February 28, 2019

RE: Application by Tarpon Towers II, LLC ("Tarpon") and Bell Atlantic Mobile Systems of Allentown, Inc. d/b/a Verizon Wireless ("Verizon Wireless") for the approvals necessary to construct and operate a 184' wireless telecommunications tower (with 4' lightning rod) and associated improvements on land owned by Calcam Associates, Inc. located off Wurtsboro Mountain Road (S.B.L. # 35-1-34) in the Town of Thompson, Sullivan County, New York (Verizon Wireless' "Louise Marie" site)

NY1137
LOUISE MARIE

SB-1

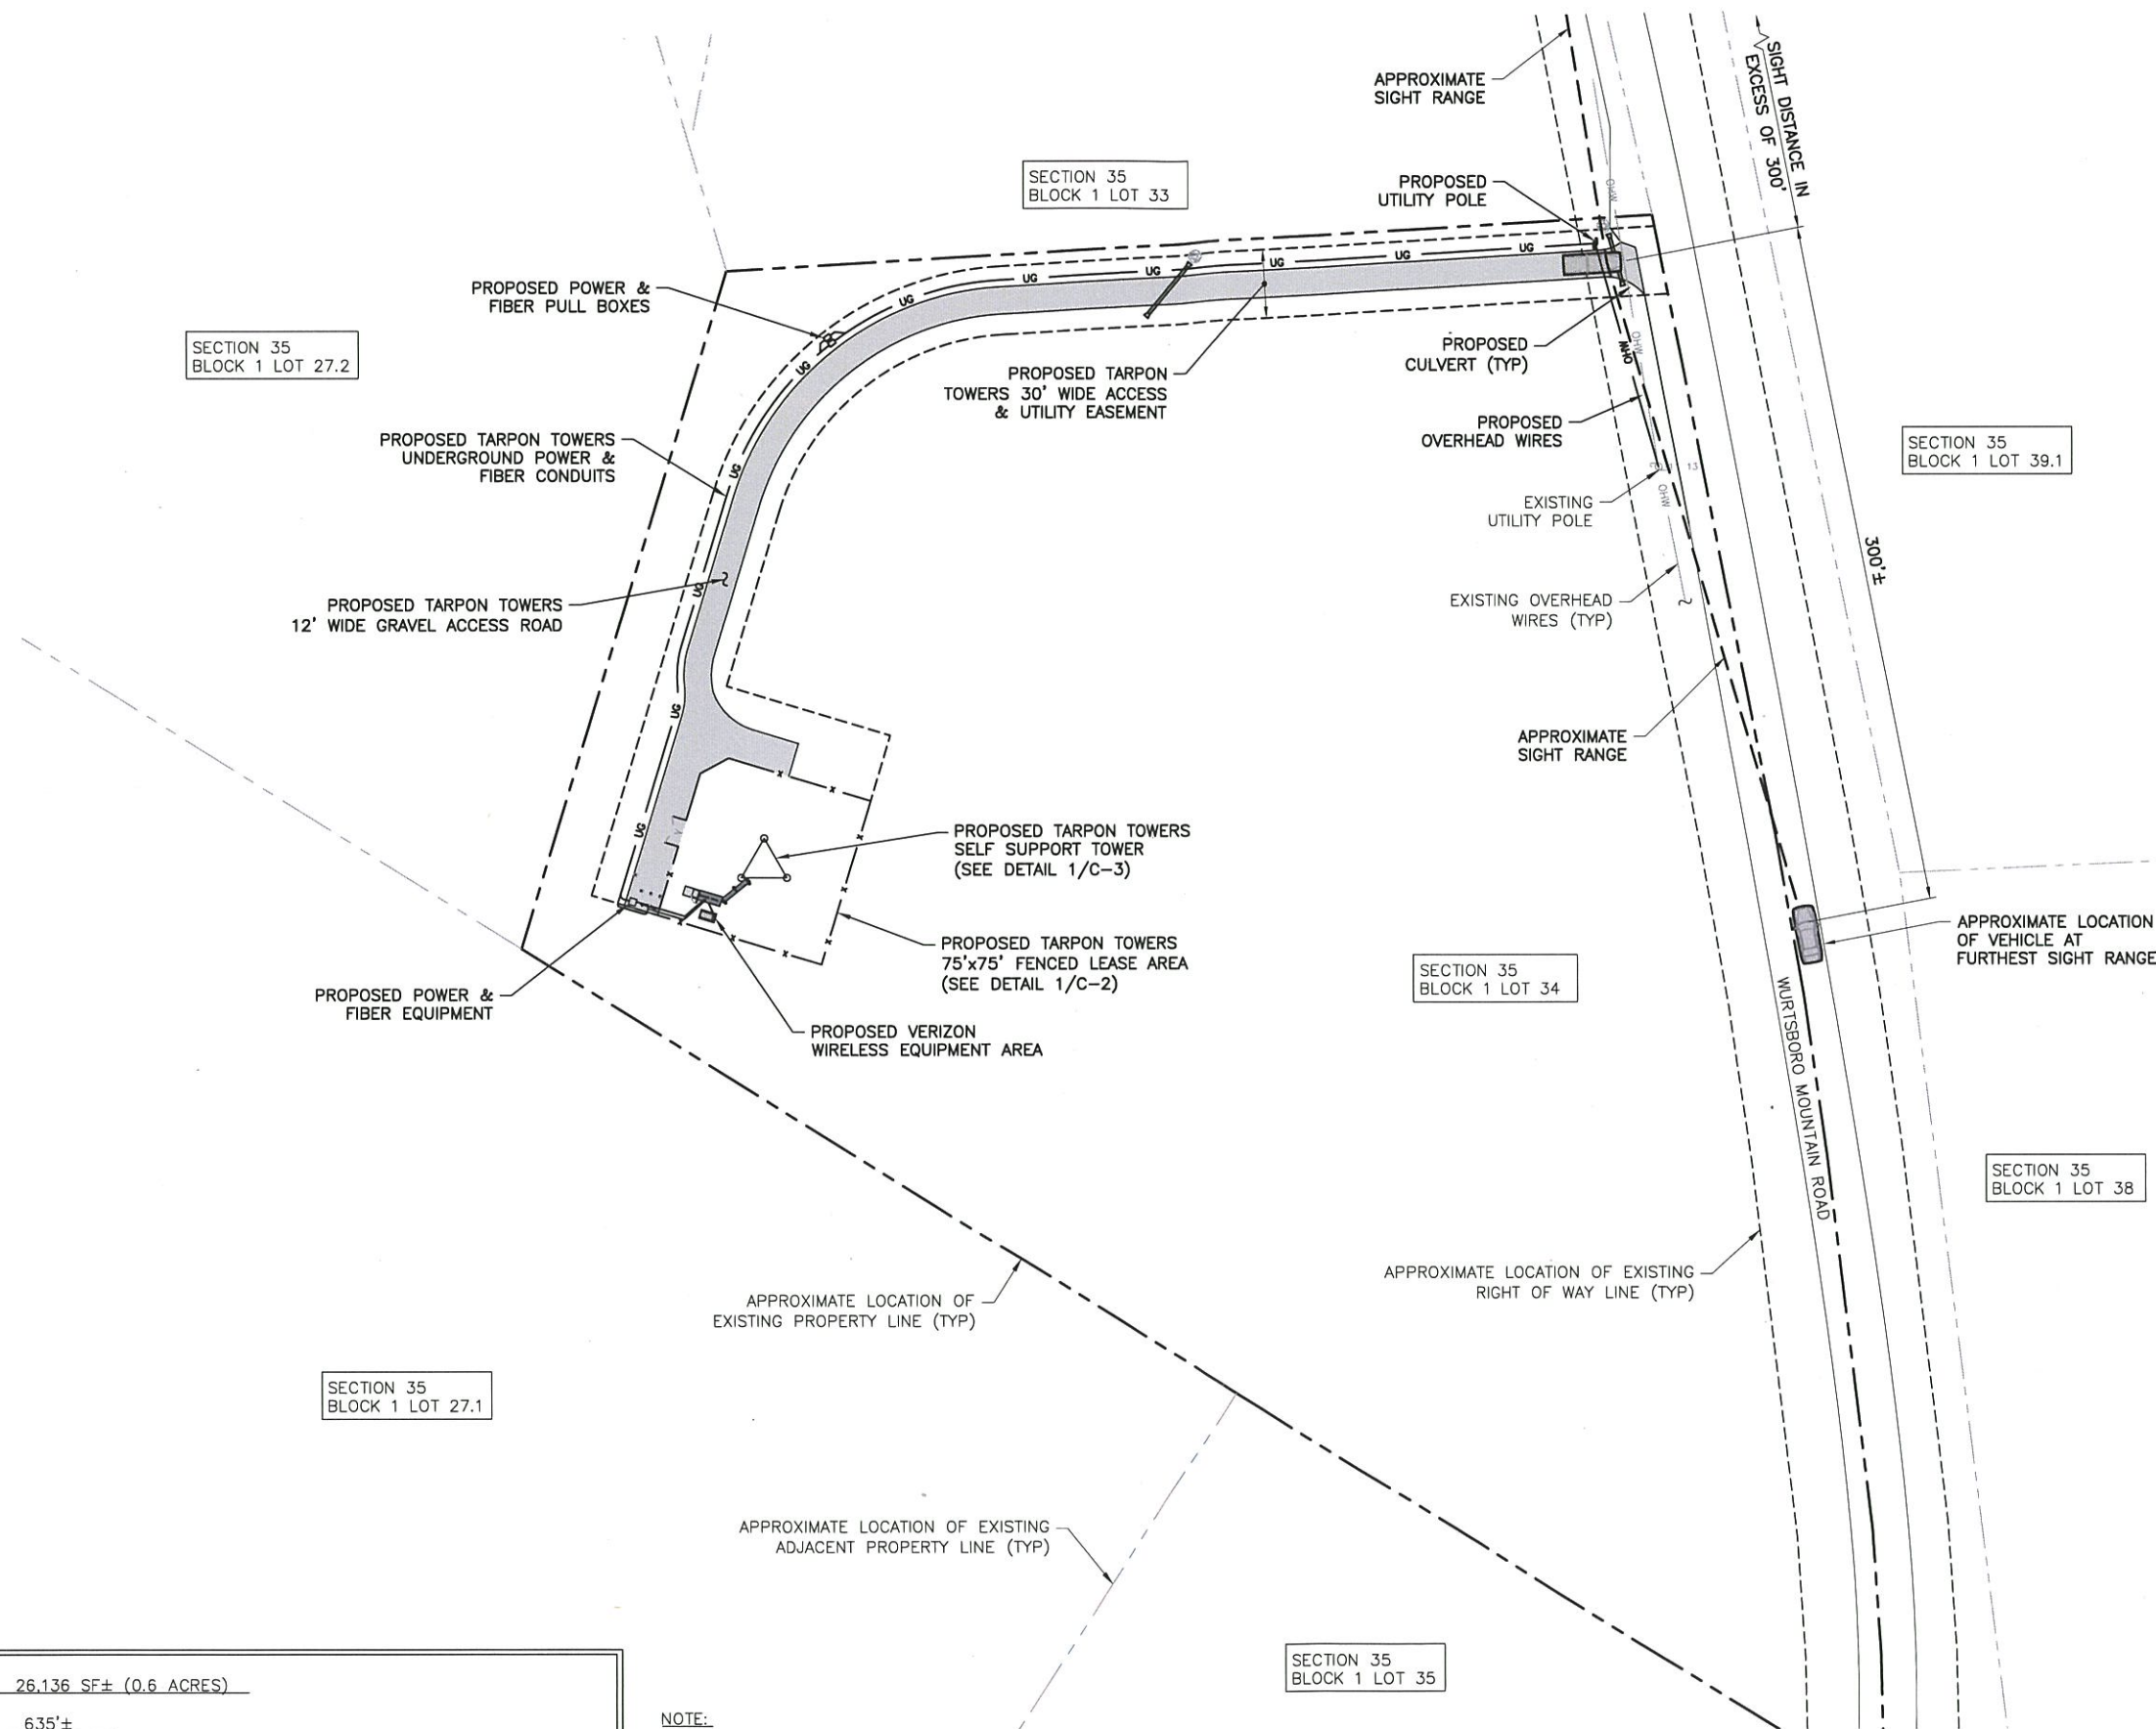
12. *Section 2 50-70 B requires that if the tower complies with the setback requirements of the zoning district the tower must be designed to fall within itself. Therefore, the documents provided should verify that the tower is designed to fall within itself.*

Response: As set forth in Exhibit Q, the proposed tower will be designed to fall within 90' of its base in the unlikely event of a tower failure.

C-1A

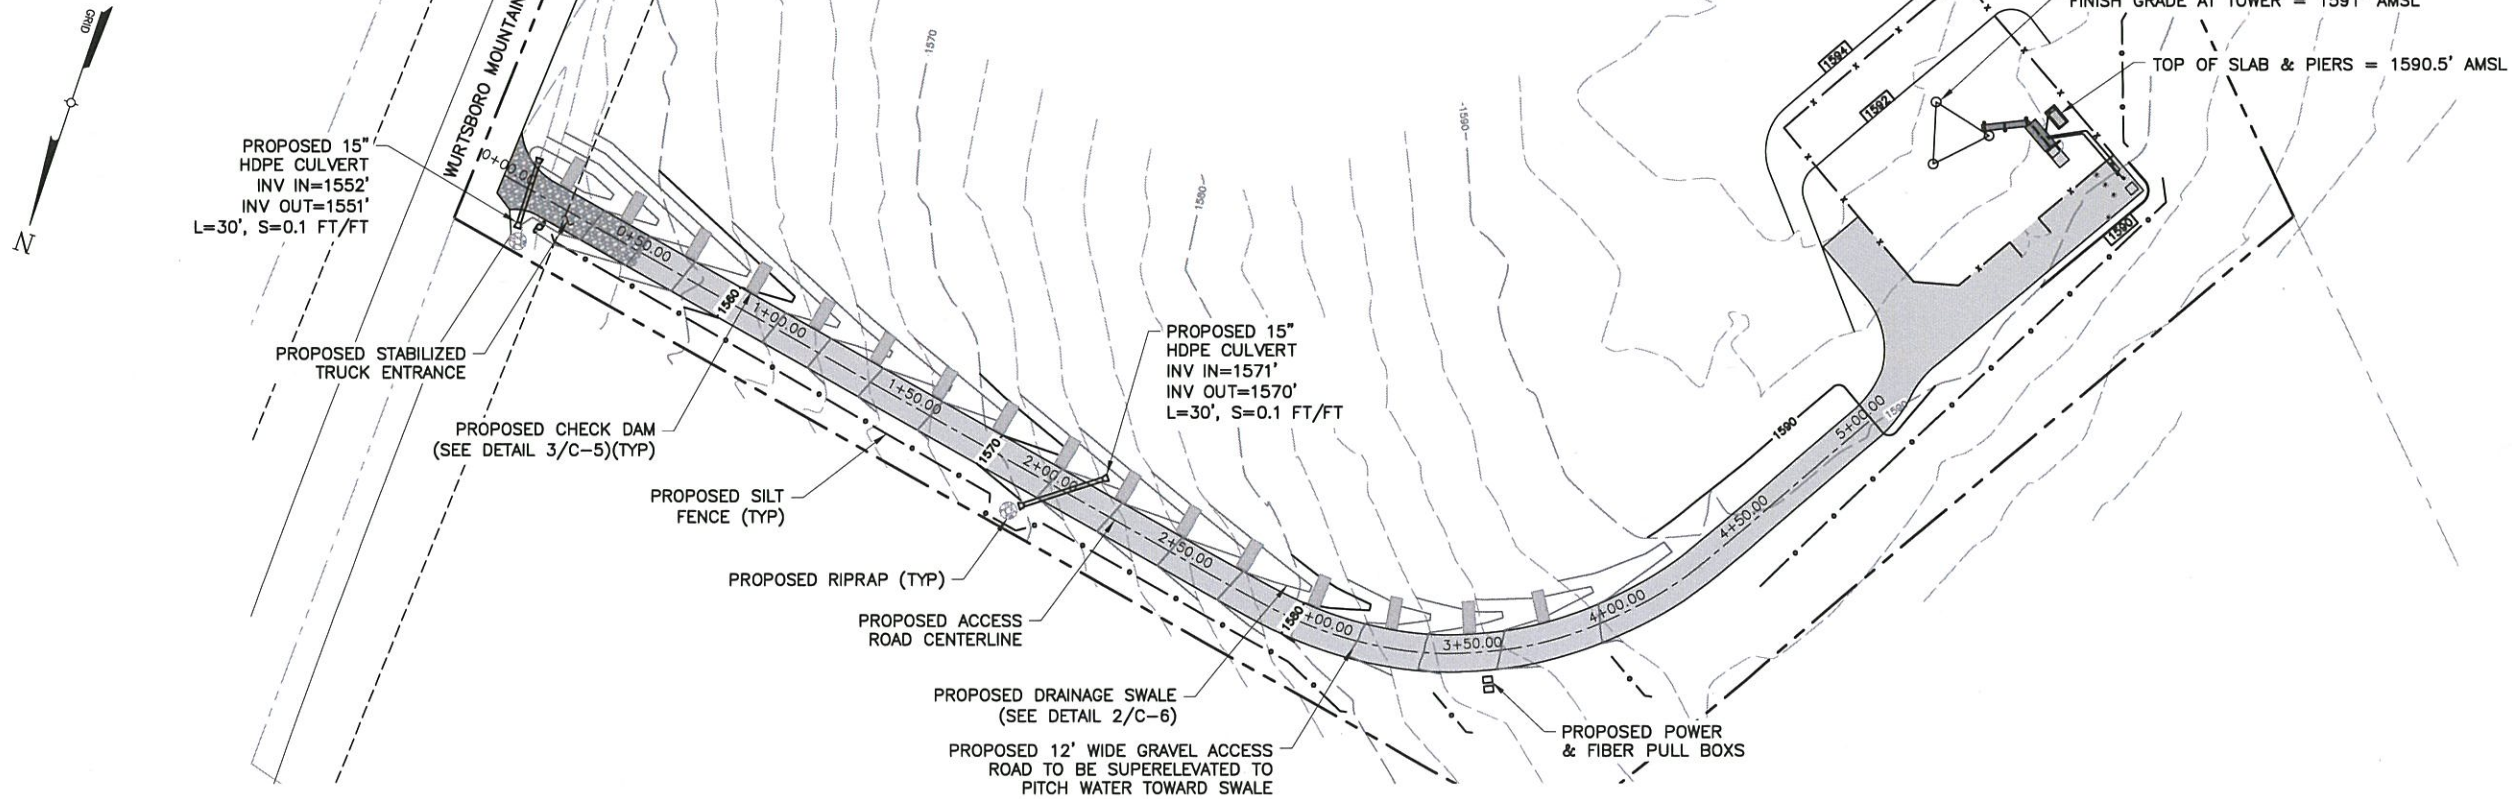
7. *Based on a field review, site distance at the newly proposed access drive may be challenging and should be noted on the site plan.*

Response: The requested information is shown on Sheet C-1A of the revised plans. The sight distance in both directions exceeds MUTCD requirements (200' minimum) for 30mph roads.

C-1B

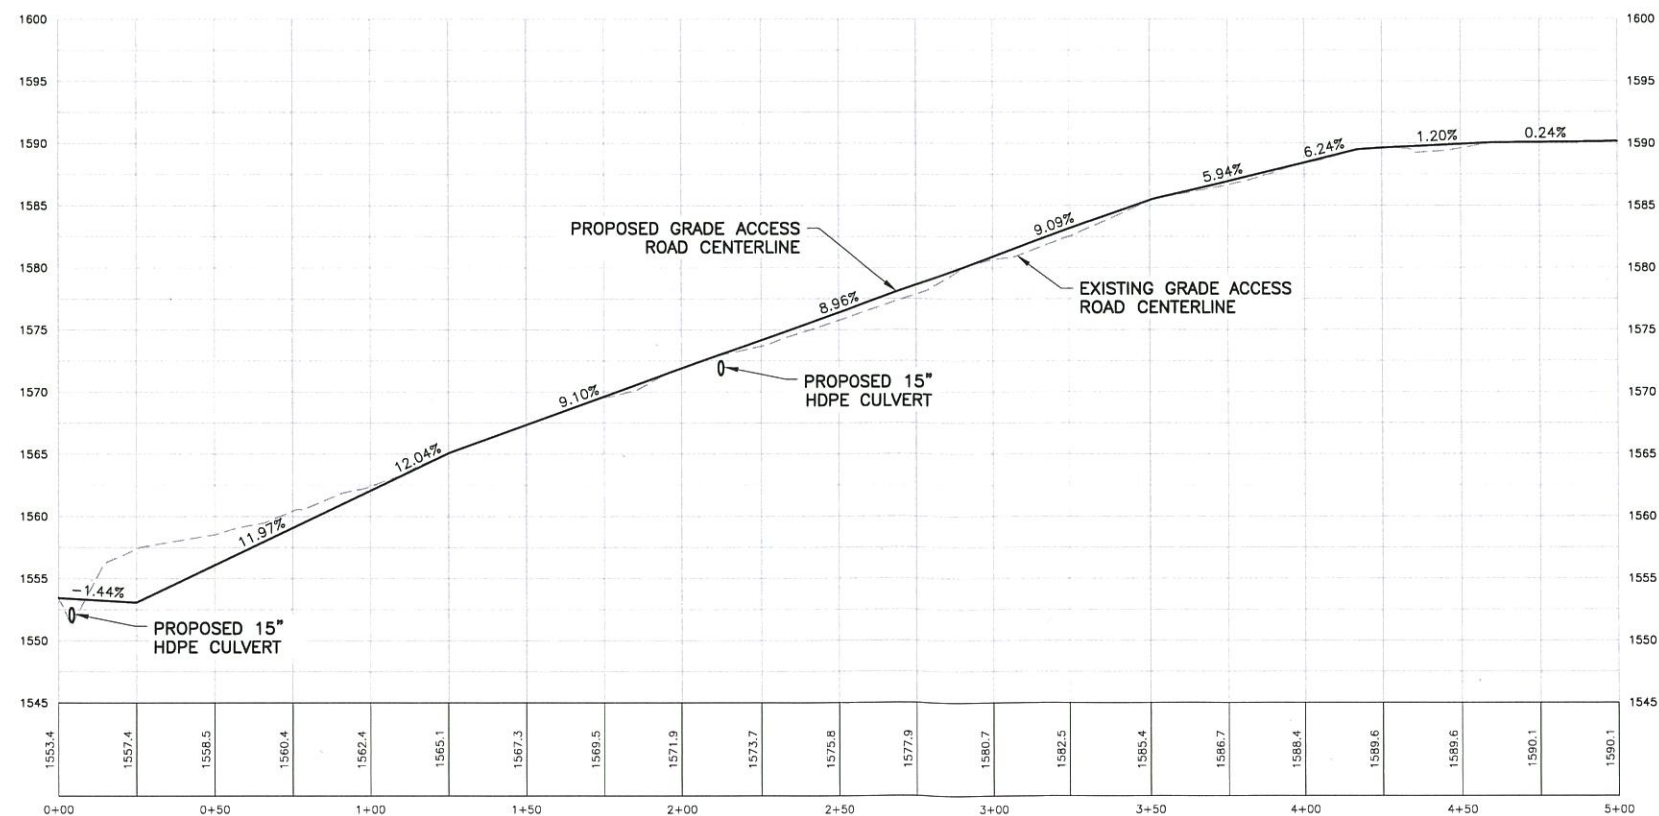
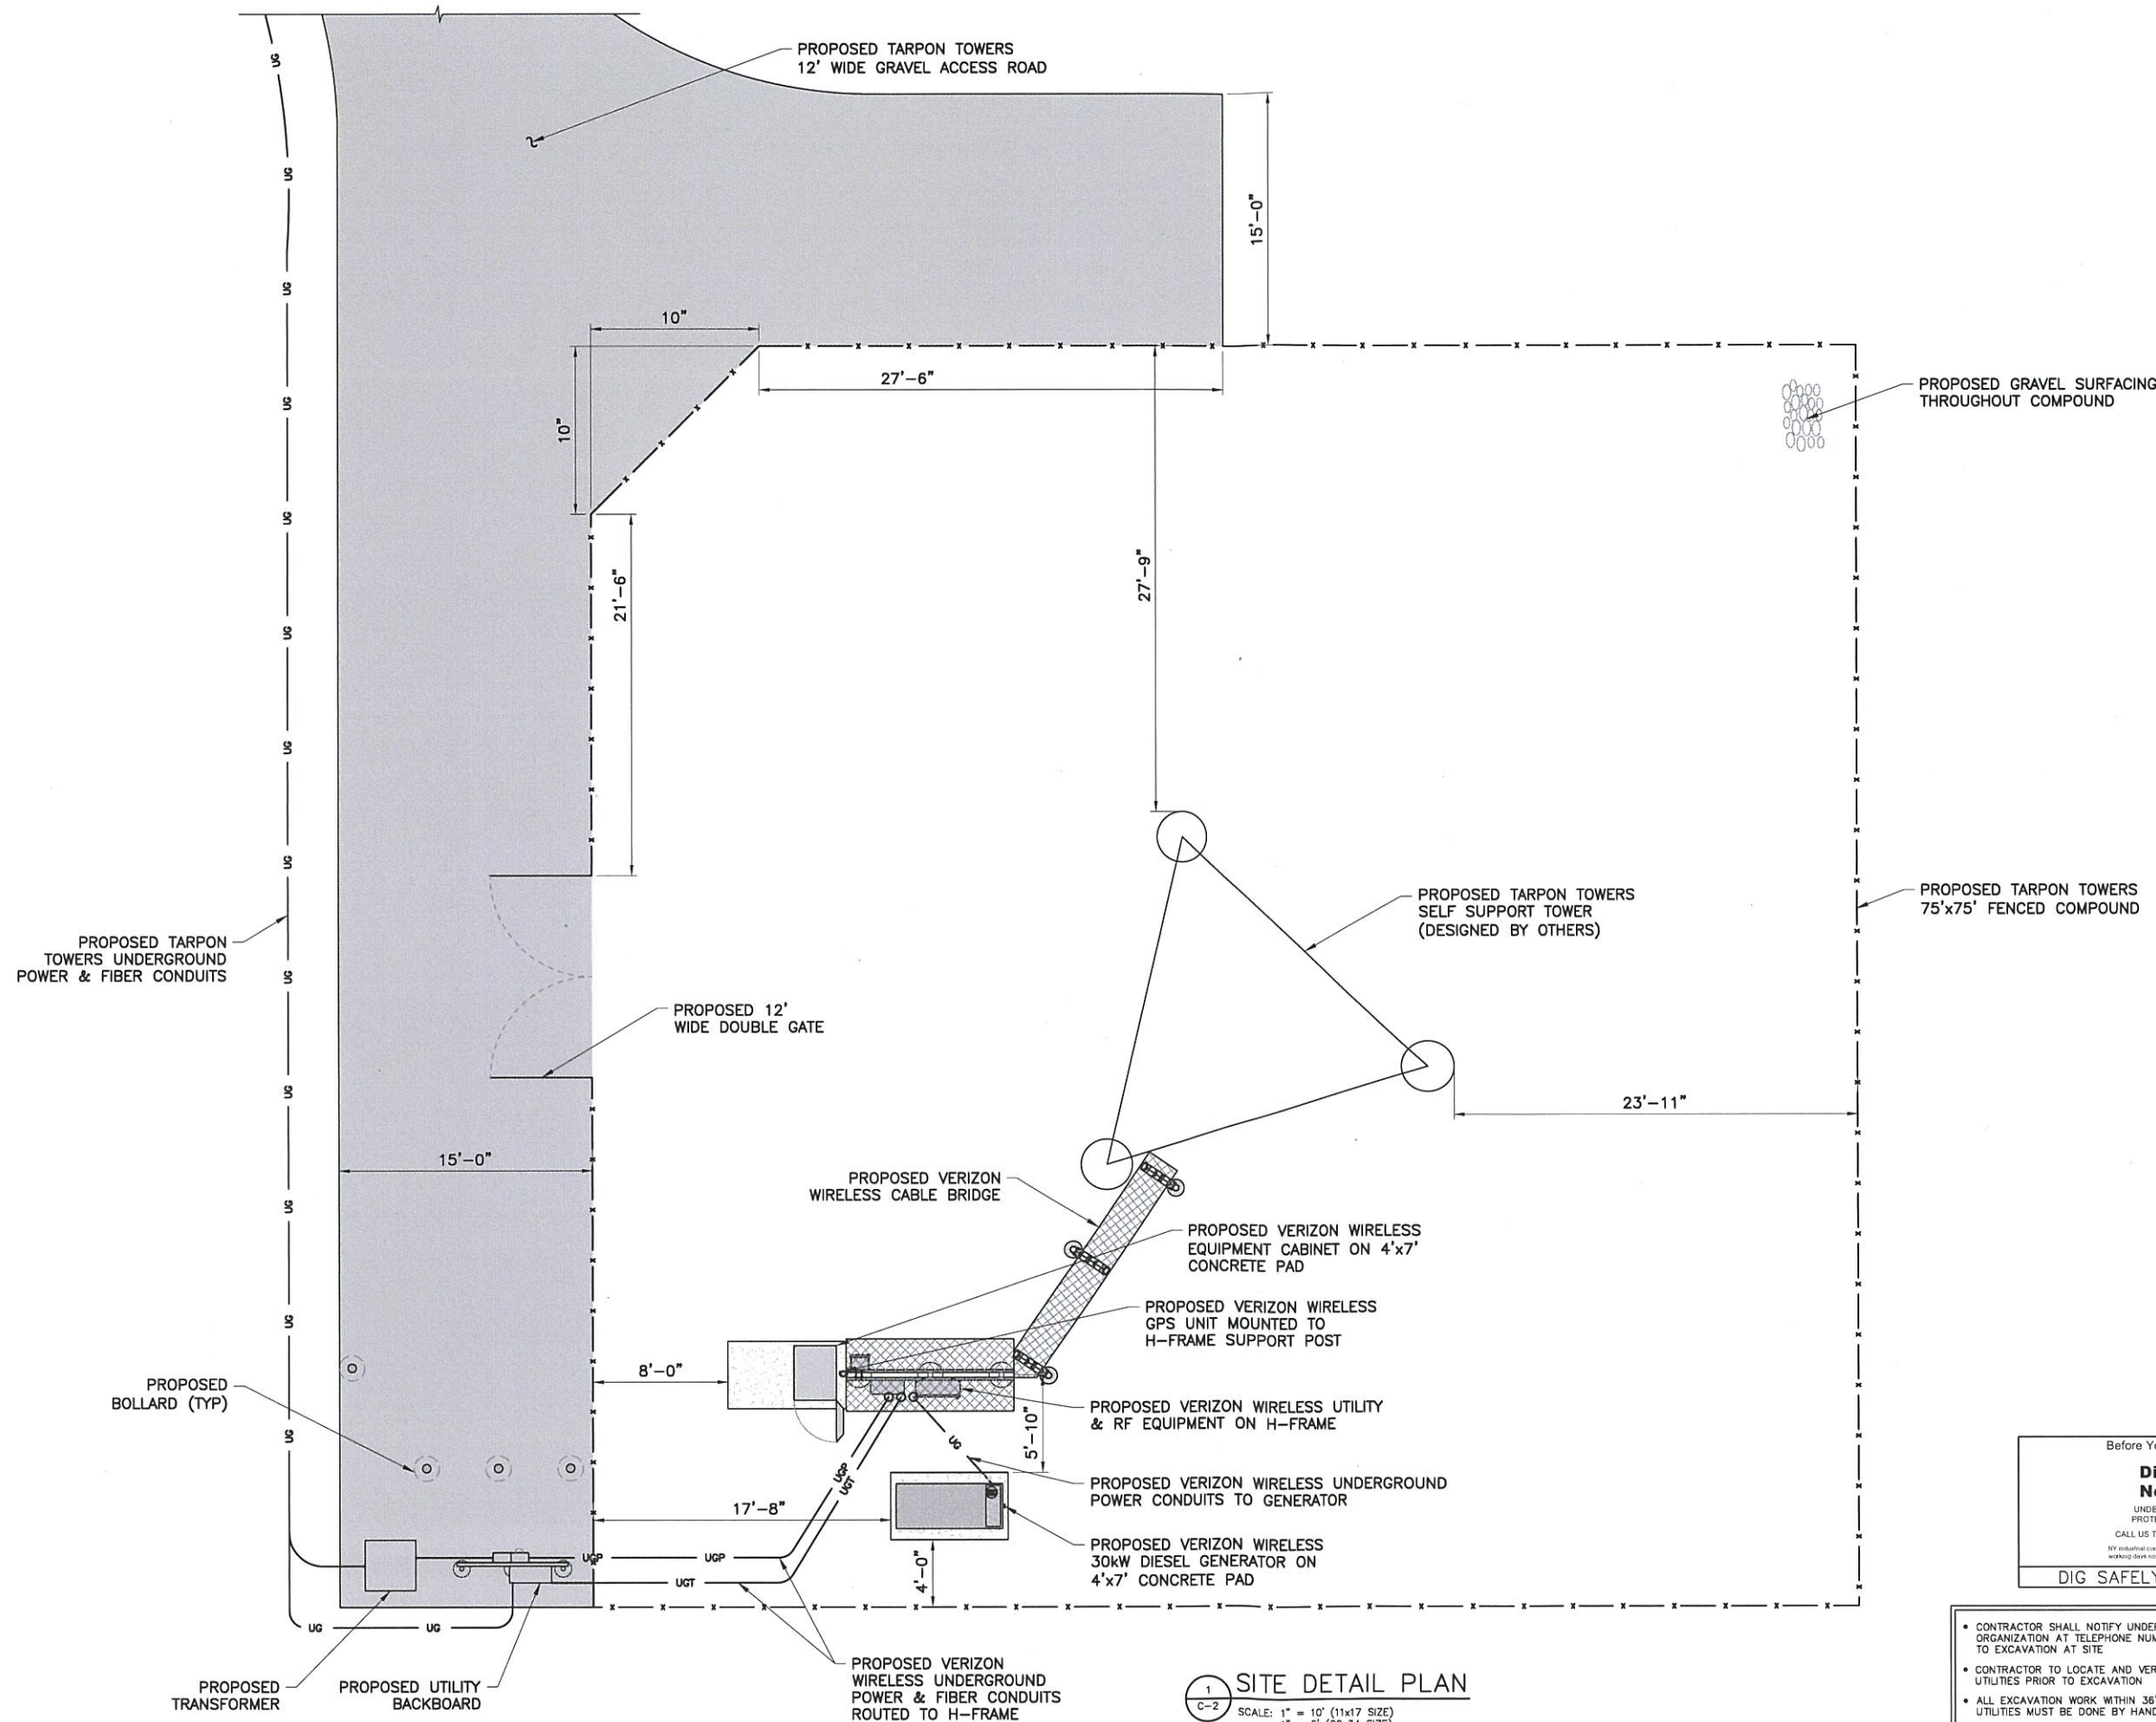
6. *The 9% grade on the access drive will require stabilized swales which should be detailed on the plans.*

Response: The requested detail is shown on Sheets C-1B, C-5, and C-6 of the Revised Plans. The new access road will create a "berm" so to speak for water naturally flowing off the top of the hill toward the W/NW. We have designed the access road with a drainage swale on the south side to capture this runoff and two culverts will divert the water under the new access road so the water can continue the natural drainage path to the W/NW. The drainage swale is a grass lined swale with stone check dams. The new access road is superelevated to pitch water into the swale. For this reason we have only designed for a swale on one side of the road (as opposed to both sides) as it captures all the runoff associated with the construction of the road.
